**REQUEST**

Current Zoning: R-5 (single family residential)  
Proposed Zoning: UR-1(CD) (urban residential, conditional)

The petition proposes to allow a single family detached home and a duplex on a vacant parcel.

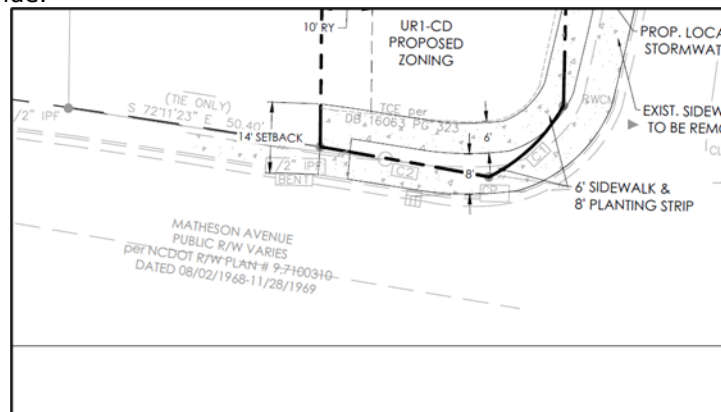
1. ~~Curbline: The proposed zoning district has a setback measured from back of the existing or proposed future curbline.~~  
~~a. Matheson Avenue: Curb and gutter to be 27 feet measured from centerline to back of curb.~~

~~Label and dimension existing curbline location on site plan measured from centerline of Matheson Avenue.~~

2. ~~Revise site plan and conditional note(s) to commit to dedicate 40 feet of right-of-way along Matheson Avenue measured from the road centerline. The site plan shall label and dimension the right-of-way from the road centerline.~~

3. ~~Revise site plan and conditional note(s) to commit to construct an 8-foot planting strip, and 6-foot sidewalk on Matheson Avenue and Pinckney Avenue per Chapter 19. The site plan shall label and dimension both items from the back of curb and gutter. Add streetscape commitments to conditional notes section of the Rezoning Plan.~~

4. ~~Revise site plan and conditional note(s) to show proposed intersection and frontage improvements of Matheson Avenue Road Conversion project project that is being done by the City's CIP project. These improvements can be shown as "by others" and in grayscale. The project scope includes converting Matheson Avenue from 4 lanes to 2 lanes, construct raised 2-way cycle track on south side of Matheson Avenue. These improvements to be coordinated with General Services and CDOT during the permitting process.~~

5. ~~Remove CDOT Notes from site plan.~~

**5. TRANSPORTATION**

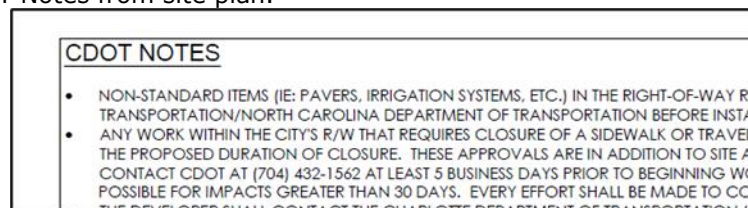
6. ~~Revise conditional note 5.A) by replacing NCDOT with CDOT as Pinckney Avenue is City-maintained.~~
